Re: National Grid comments on the United States Environmental Protection Agency Proposed Remedial Action Plan for the Gowanus Canal

**Comments on the
United States Environmental Protection Agency
December 2012 Proposed Remedial Action Plan for
the Gowanus Canal Superfund Site**

Submitted April 25, 2013

Figure 4. Fate of suspended sediments introduced into the Canal via the flushing tunnel; Existing Conditions Bathymetry

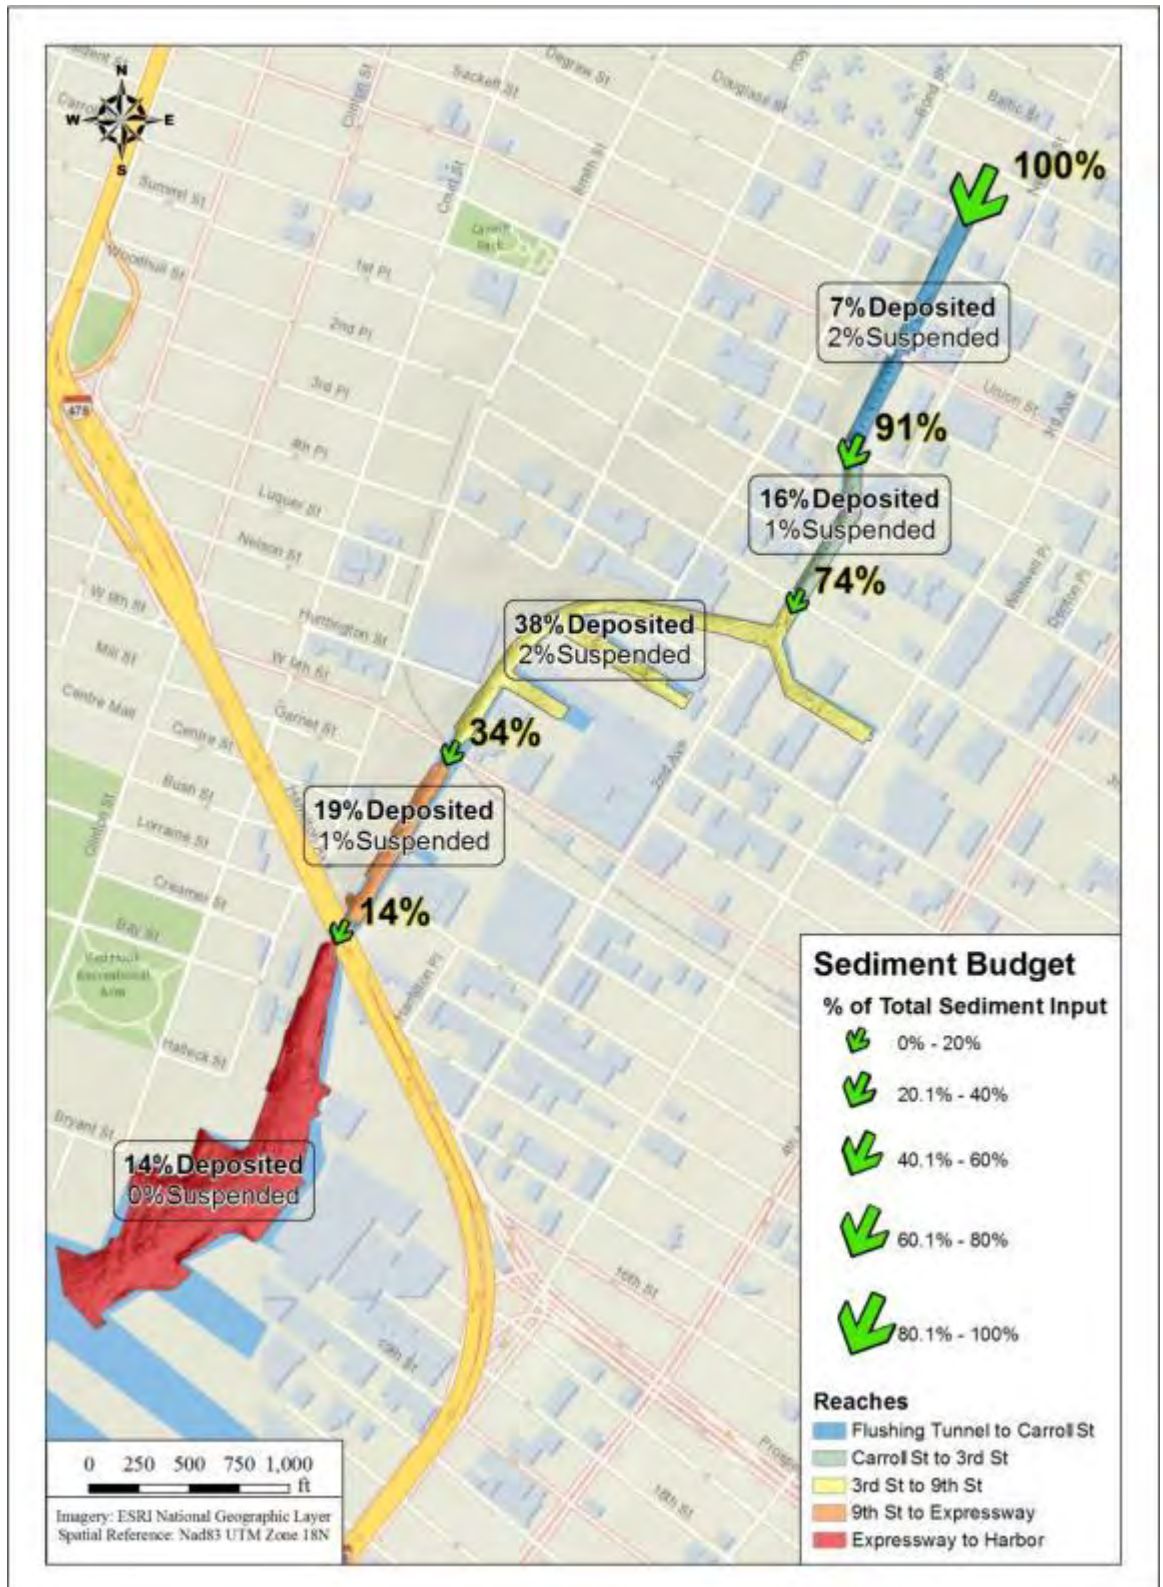
Background suspended sediments present in Buttermilk Channel will be introduced to the Canal through the flushing tunnel (FT) upon its reactivation. Figure 4 shows when the flushing tunnel is active, with the existing Canal bed configuration, sediments from the tunnel are deposited primarily in the central, deeper section of the Canal (RTA 2). This is so because flow slows down due to the increase in channel depth. Dredging in RTA 2 to an even greater depth, with a target elevation of -16 feet further reduces the ability of the flushing tunnel to move sediments and contaminants through the Canal to the Harbor, as the flow speed in RTA2 decreases due to the proposed increase in depth (Figure 3).

Figure 5. Sediment budget showing fate of flushing tunnel sediments under remedial alternative conditions. Zone of major deposition in RTA2 highlighted in red

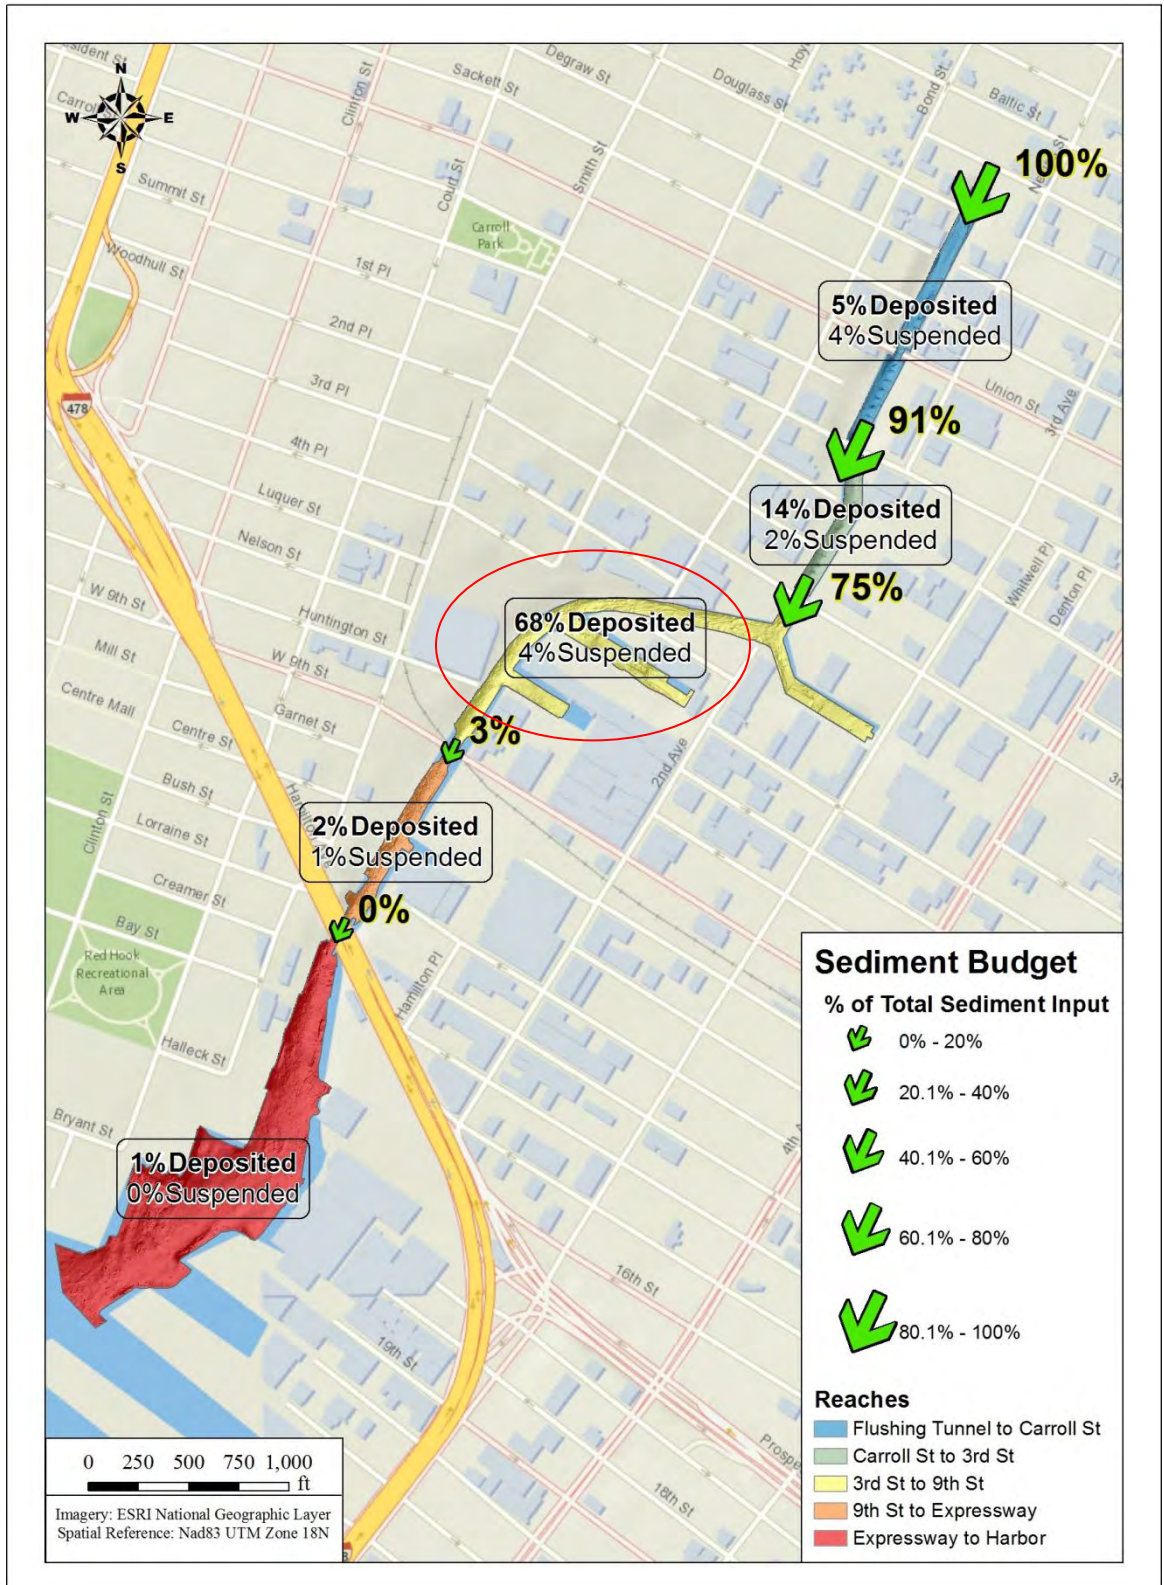
- **Varying depths in the Canal must be considered.** Figure 5 shows when the flushing tunnel is active, sediments from the flushing tunnel are deposited primarily in the central, deeper section of the Canal (RTA 2). This is so because flow slows down (and it is exclusive of the influence of commercial navigation, which will cause sediments to be regularly resuspended and deposited). Deep dredging in RTA 2, however, will reduce the ability of the flushing tunnel to move sediments and contaminants through the Canal to the Harbor. Similarly, the -16 feet target elevation for RTA 2 is not realistic, given ongoing commercial navigation in this section of the Canal. Propeller scour will require an armor layer consisting of large cobbles to boulders to prevent damage to the cap. Sediments deposited above the armor layer would be subject to regular remobilization and redeposition under the influence of vessel traffic. Lastly, the transition from “shallow” (-9 feet) in RTA 1 to “deep” (-16 feet) in RTA 2 leads to deposition in RTA 2 of CSO sediments and contaminants, sediments from the flushing tunnel, and sediments remobilized from the sand benthic layer in RTA 1. These sediments will be subject to remobilization by vessel activity. If this section of the Canal is made deeper to accommodate commercial vessel navigation, conditions may be significantly worse. Given these scenarios, all commercial navigation should be stopped.

Figure 8. Comparison of modeled Remedial Design conditions with Existing Conditions for the Hurricane Irene event

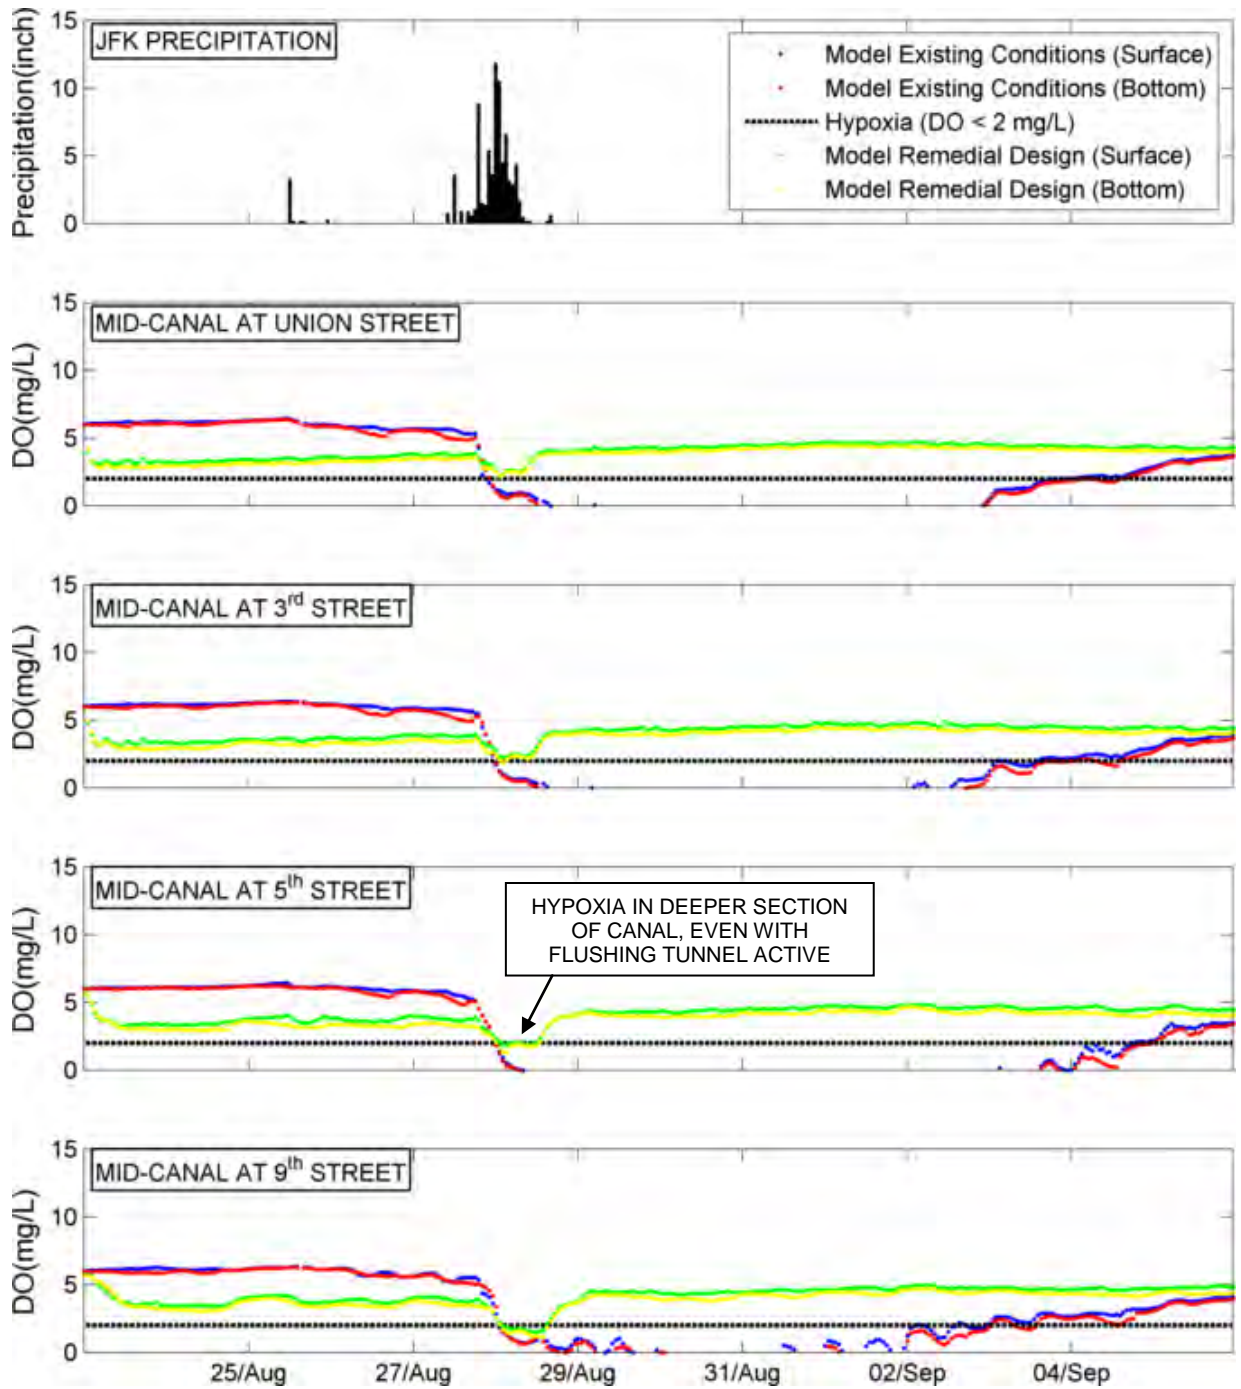
A long-term simulation of dissolved oxygen (DO) levels in the Canal was completed for the time period from 1 November 2010 to 31 October 2011. CSO flows from the watershed hydrologic and sediment supply model were included in the WQ model. Observed and predicted hypoxia and anoxia from the long-term validation runs are shown in Figures 6 and 7. The results show that predicted DO levels agree well with observed values throughout the year, and also spatially throughout the model domain. Throughout the model year, the Canal was repeatedly subjected to hypoxic and anoxic conditions as a result of CSO flows during storm events and the limited flushing capability of the Canal without the flushing tunnel. The DO model results also suggest there may be periods of hypoxia in RTA 2, even when the flushing tunnel is active (Figure 8).

Figure 1. CSO Sediment Core Locations (Collected August 2012 by GEI)

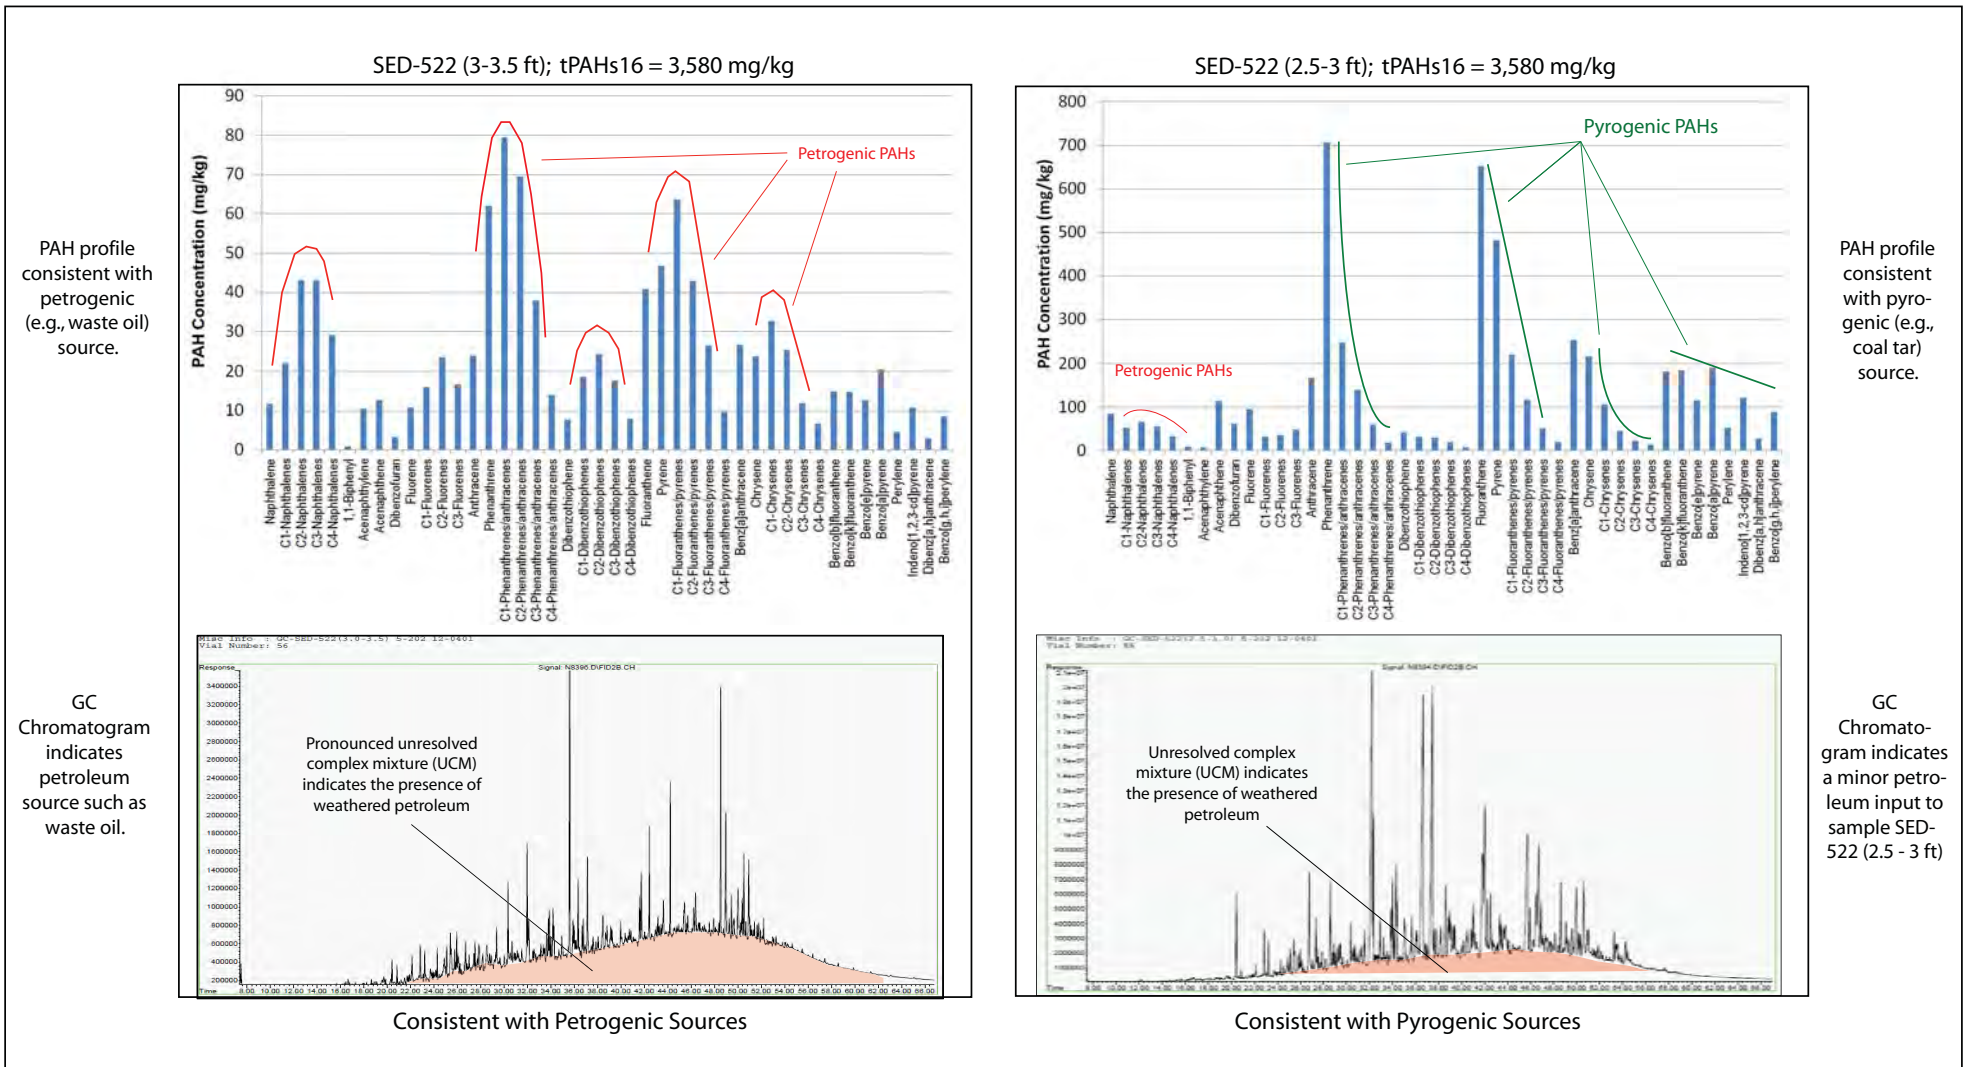
Analytical results for sediment samples from mounds near CSO RH-031/OH-602 (see Figure 1)

Results for CSO RH-035/OH-007 sediment samples (see Figure 1)

Results for sediment mounds at the northern reach of the Canal (see Figure 1)

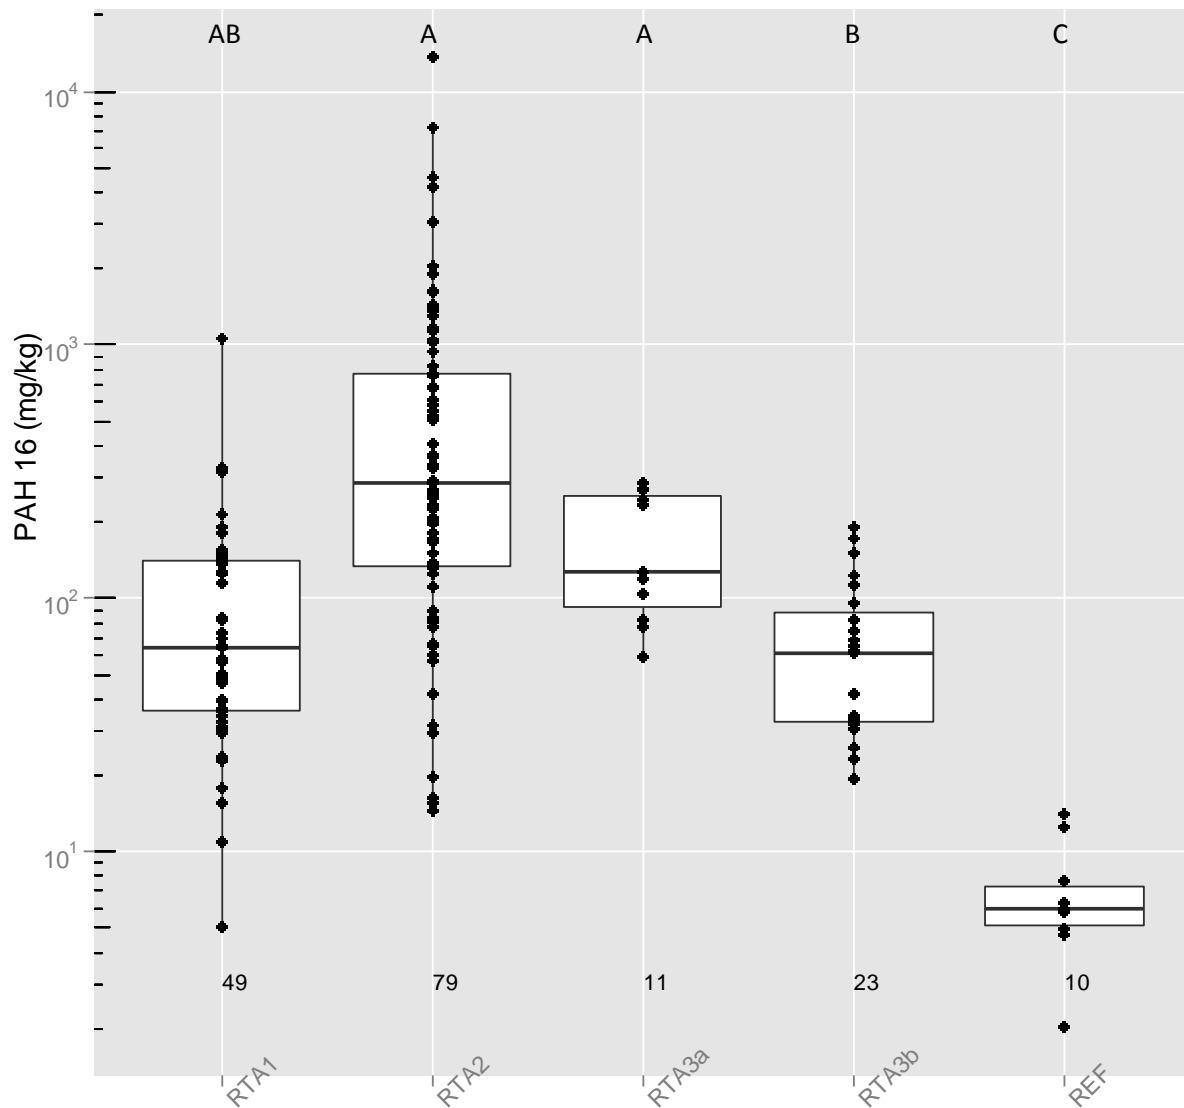
Total PAH16 in surficial (zero to six inch depth) sediments, measured as the sum of the 16 EPA priority pollutant PAHs, was greatest in RTA 2 and the least in RTA 1 and RTA 3b (Figure 1 of Appendix L). Statistical analysis indicated significant pairwise differences between RTA 3b and all other areas, though RTA 3b is most similar to RTA 1. Concentration ranges of total PAH16 in subsurface samples in each RTA generally overlap with those of surficial concentrations (Figure 2 of Appendix L). However, the noticeably lower concentrations of total PAH16 within RTA 3b surficial sediment may be the result of natural recovery processes.

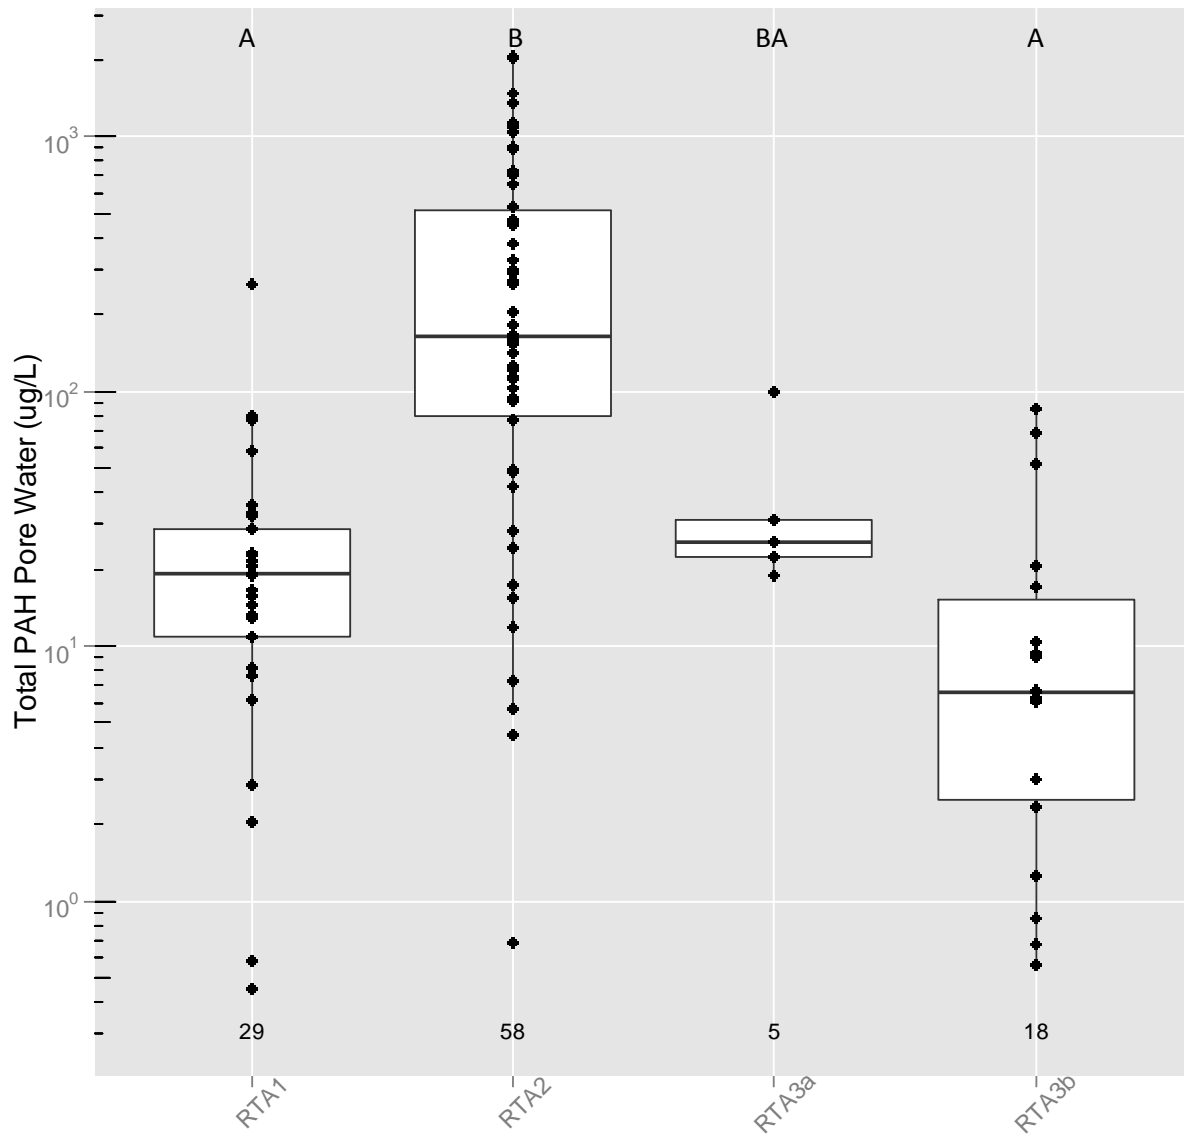
Total PAH34 in surface sediment pore water (i.e. interstitial water), measured as the sum of parent and alkylated PAHs using solid phase micro-extraction (SPME), was consistent with bulk surface sediment PAH16 results: Concentration was greatest in RTA 2 and the least in RTA 1 and RTA 3b (Figure 3 of Appendix L). The median PAH34 concentration in pore water was the least in RTA 3b, which may at least partially explain the benthic community results discussed in the next section.
